From: Tilley, Corinne (CI-StPaul)
Sent: Tuesday, January 07, 2014 3:16 PM
To: bob@trikin.com; Spiering, Wayne (CI-StPaul); brettking@gmail.com
Cc: Vang, Mai (CI-StPaul)
Subject: Email comments of site plan review application for 590 Reaney Avenue (586 Reaney Ave)
Attachments: 20140107150824175.pdf

Applicant: Bob Fluegel of Trikin LLC
Property owner: Brett King

You are proposing to construct a new 6 vehicle paved parking lot on the vacant lot at 590 Reaney Avenue. The standard parking space dimensions are 9'x18'.

REVISED SITE PLAN

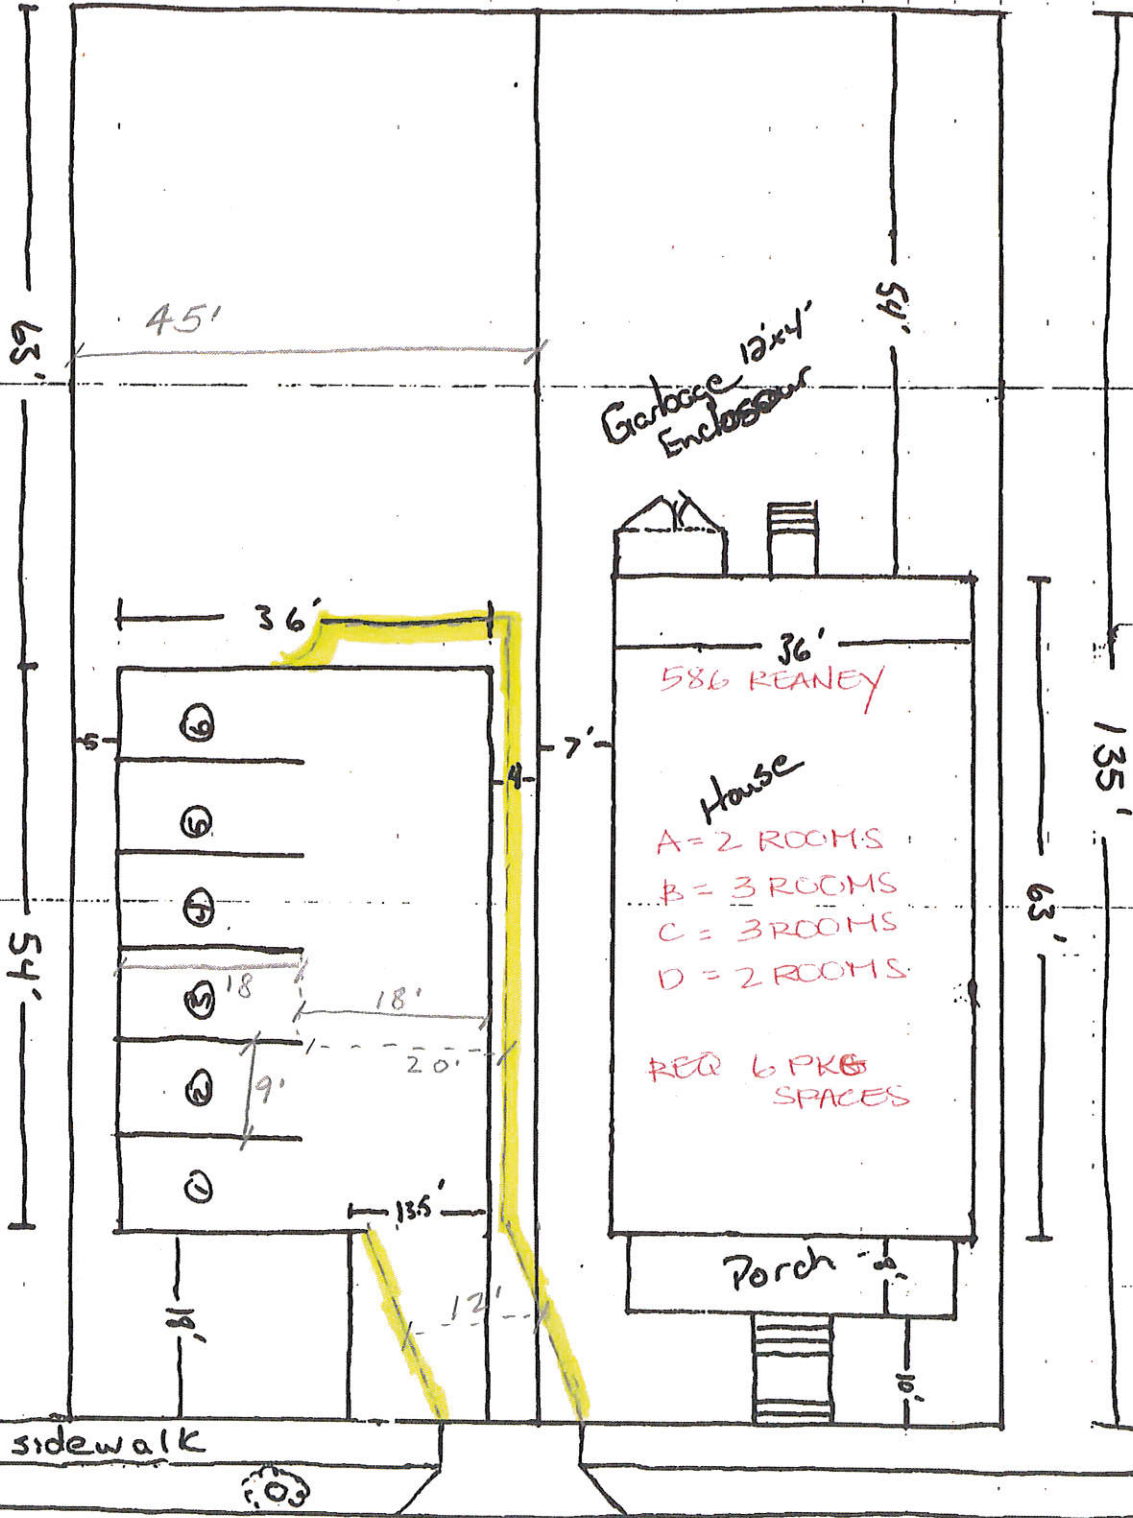
Access to the off-street parking facility shall be provided by a maneuvering lane so that any vehicle leaving or entering the facility from or onto a public street shall be traveling forward.

Submit a revised site plan that shows how you would meet this requirement.

Please refer to the attached PDF. I have highlighted (in yellow) a possible option in revising the site plan to meet this maneuvering requirement.
